Addendum No. 2

RFT 24-061 Gymnasium Addition - Glenview Public School

ADDENDUM #1

Project	Glenview PS Gym Addition	Project No.	2314
Location	143 Townsend Ave., Burlington, ON	Date of Issue	2024 05 17
Owner	Halton District School Board	File	2314/7.1.3

BUILDING & WALL SECTIONS

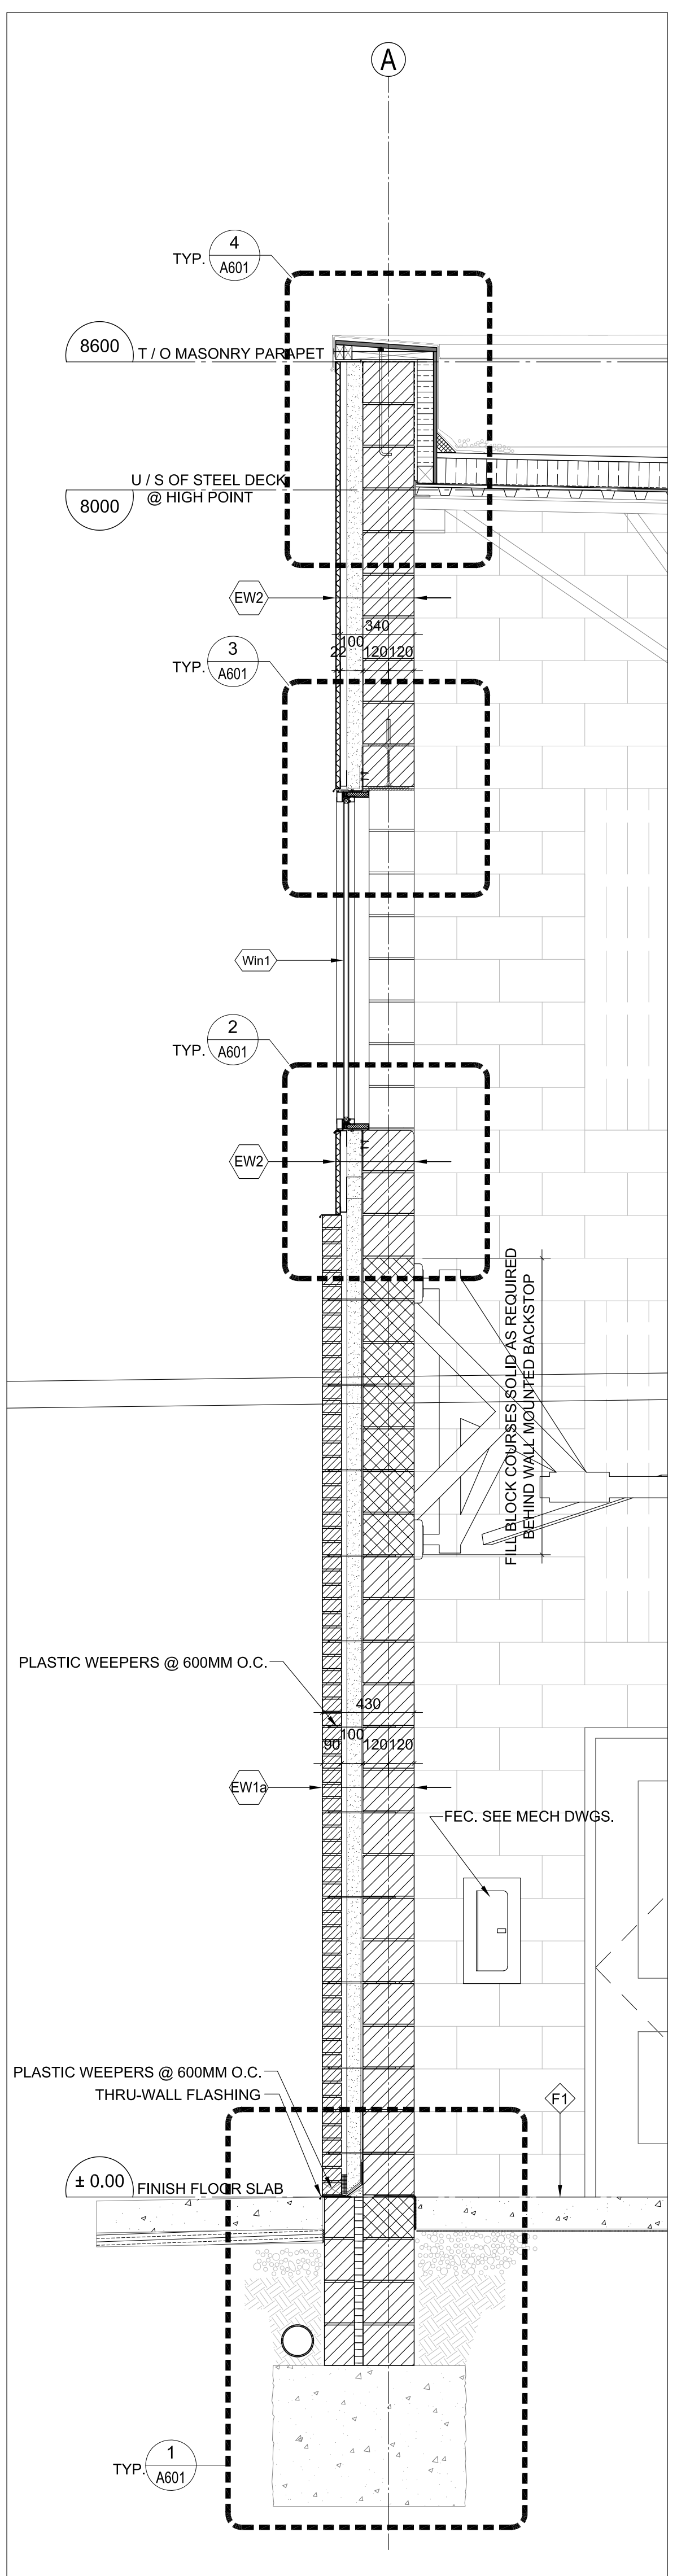
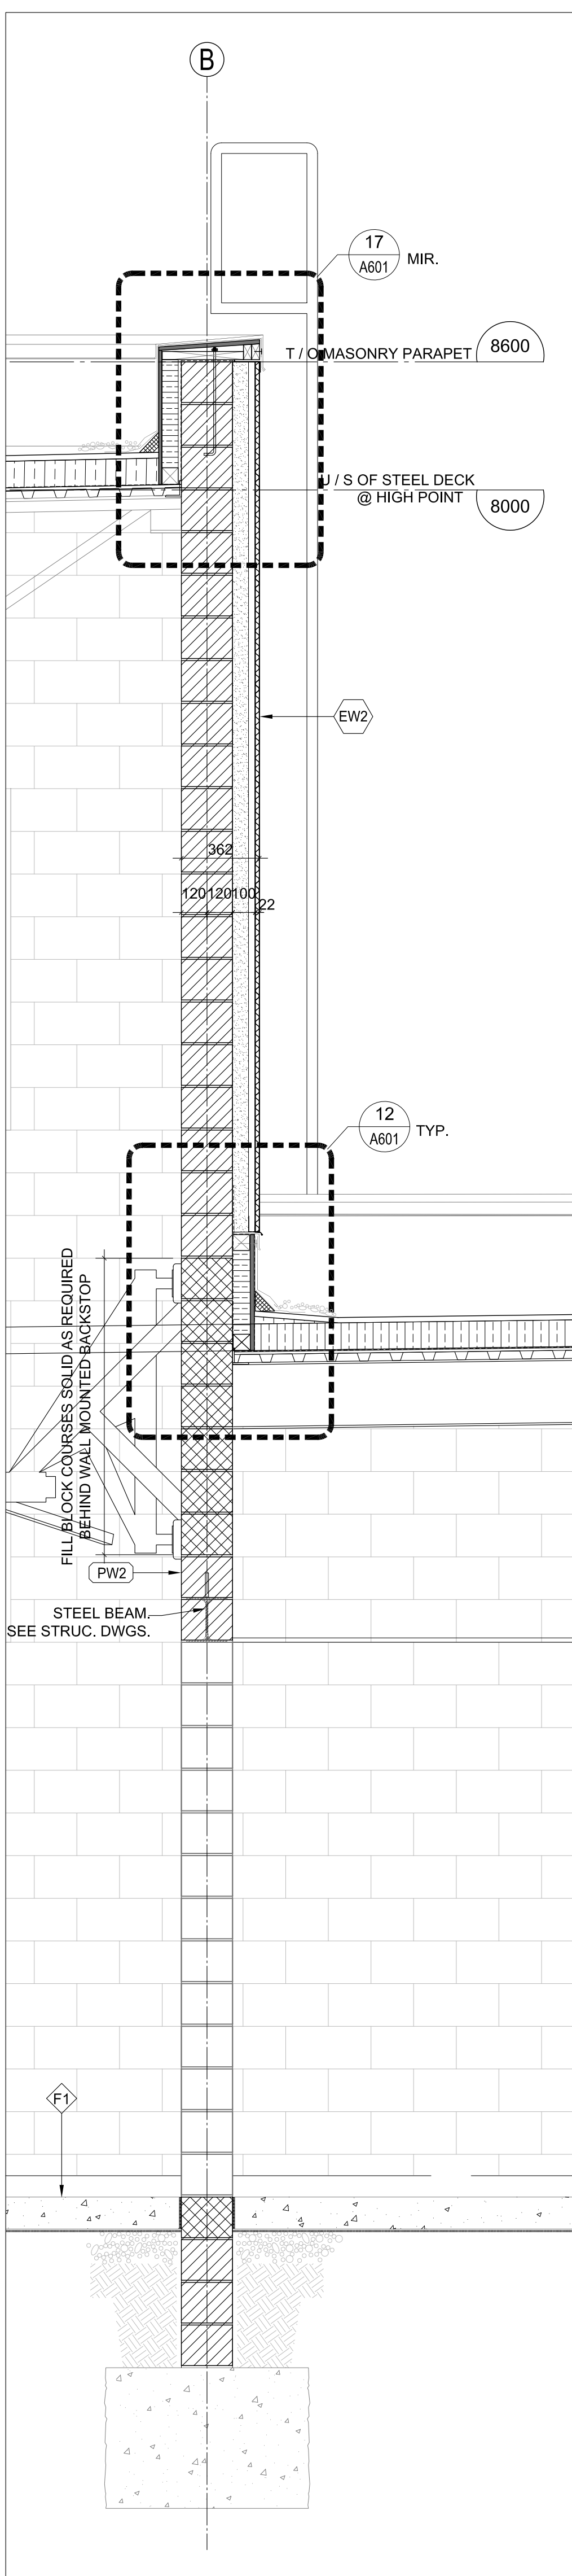
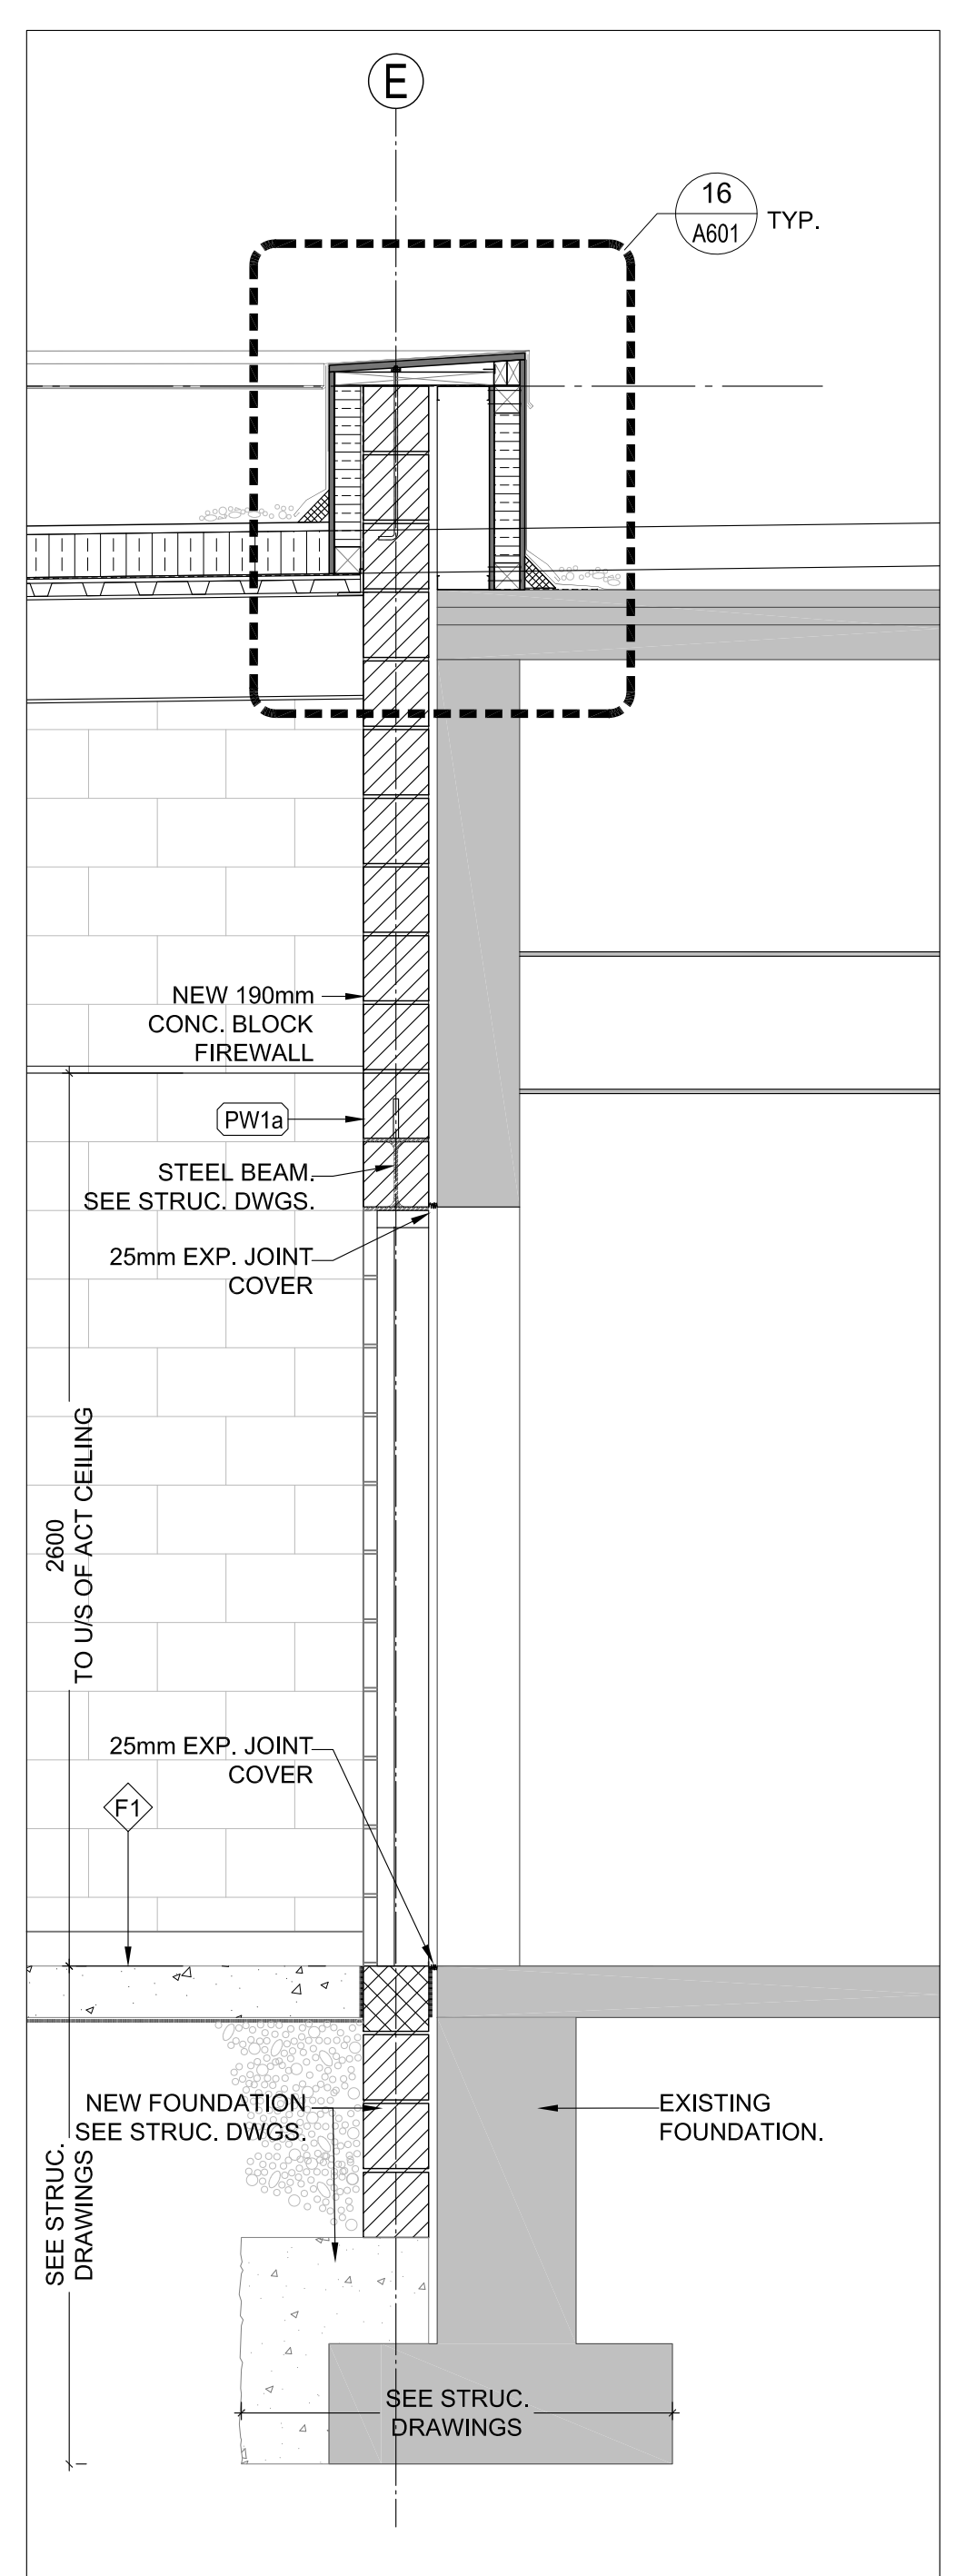
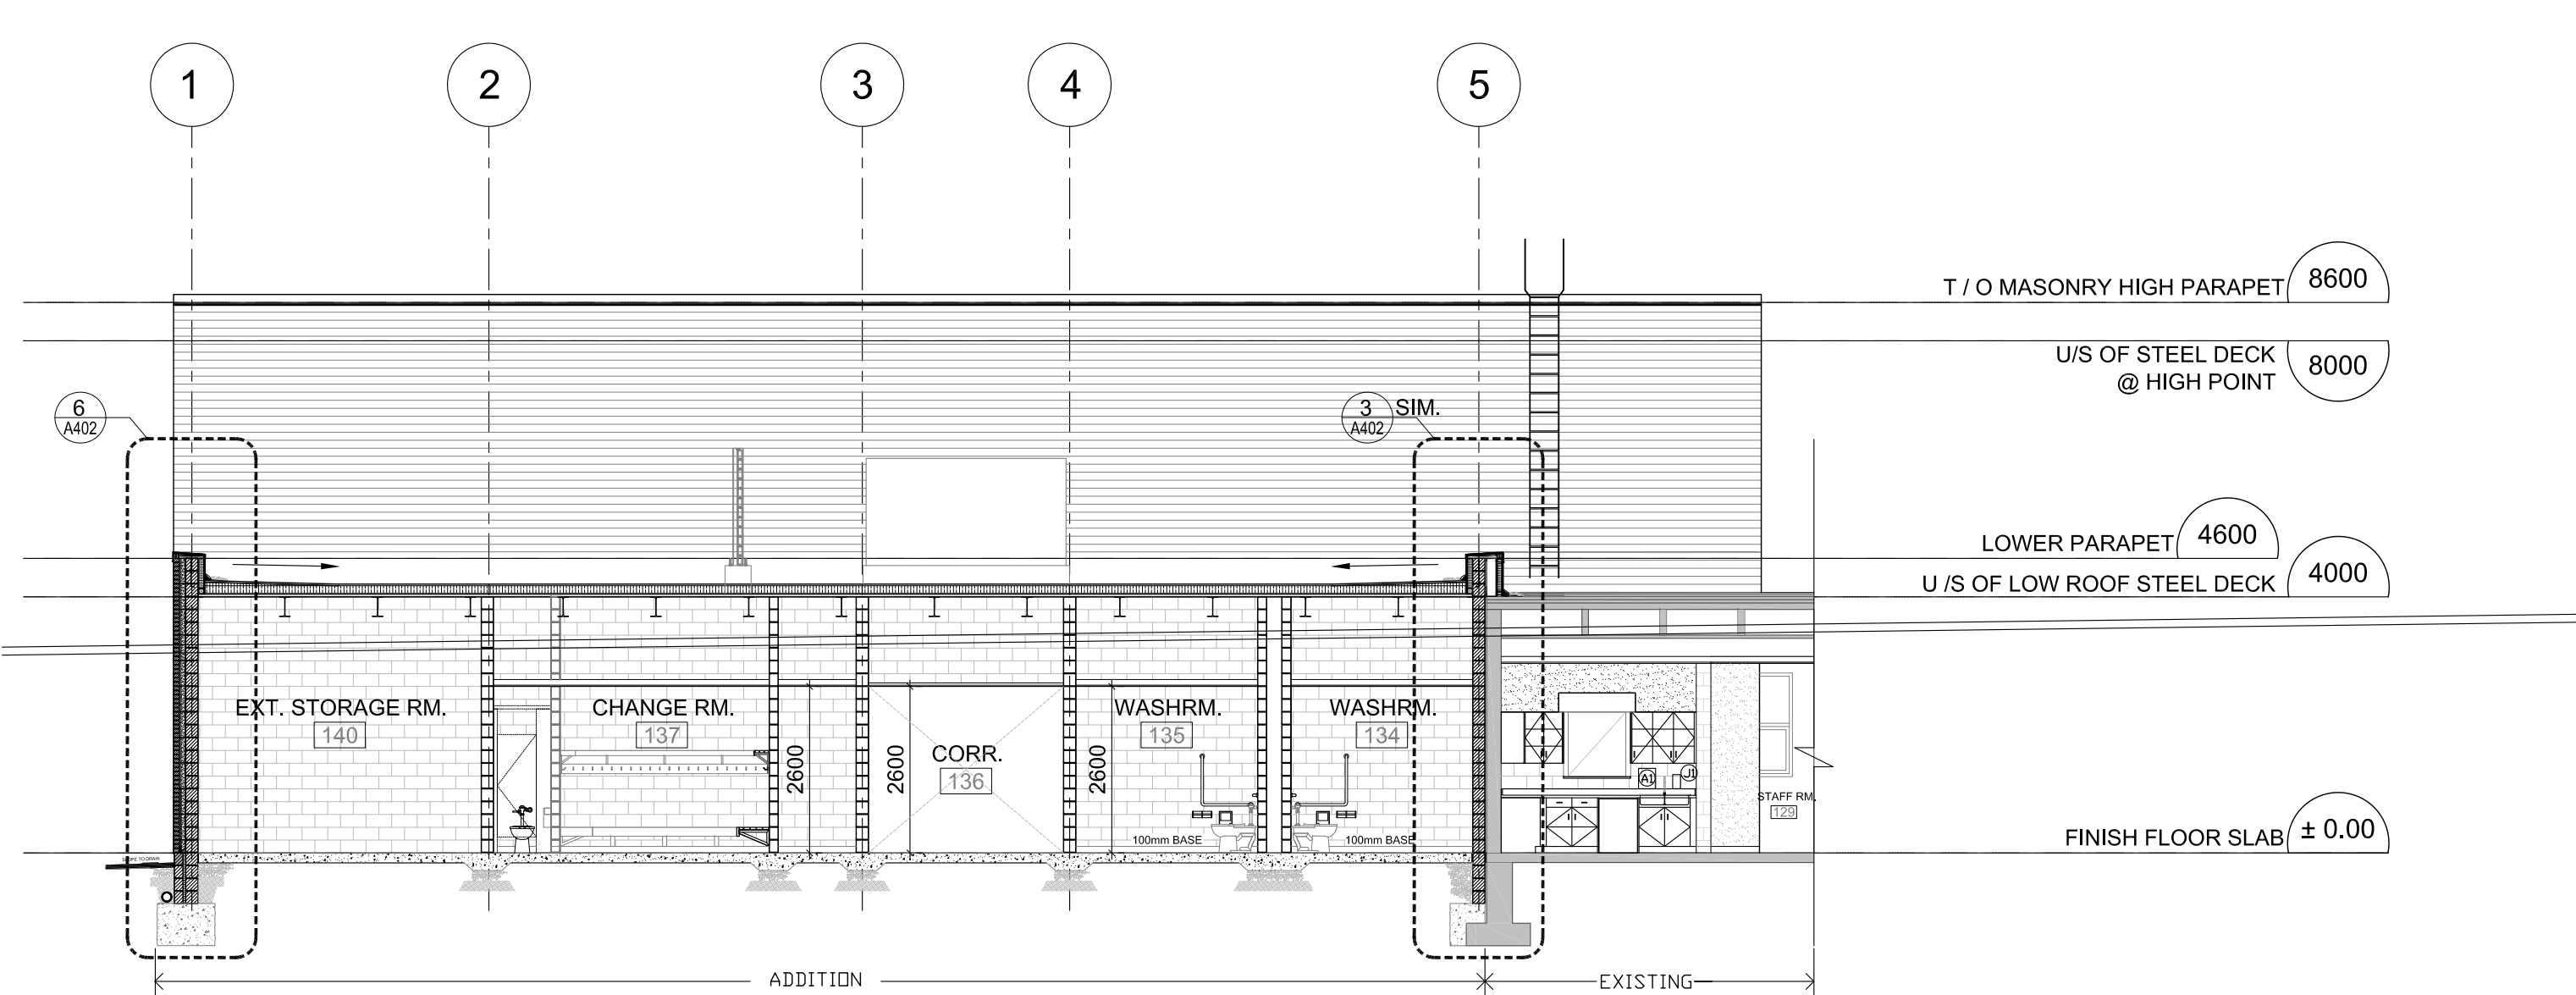
A1-5 DRAWING A402 BUILDING & WALL SECTIONS

- .1 Replace Drawing with the attached Revision No. 3.
- .2 Drawing reissued to revise detail callout tags at 3/A402, 4/A402, 5/A402 and 6/A402 to correspond with details on drawing A602.
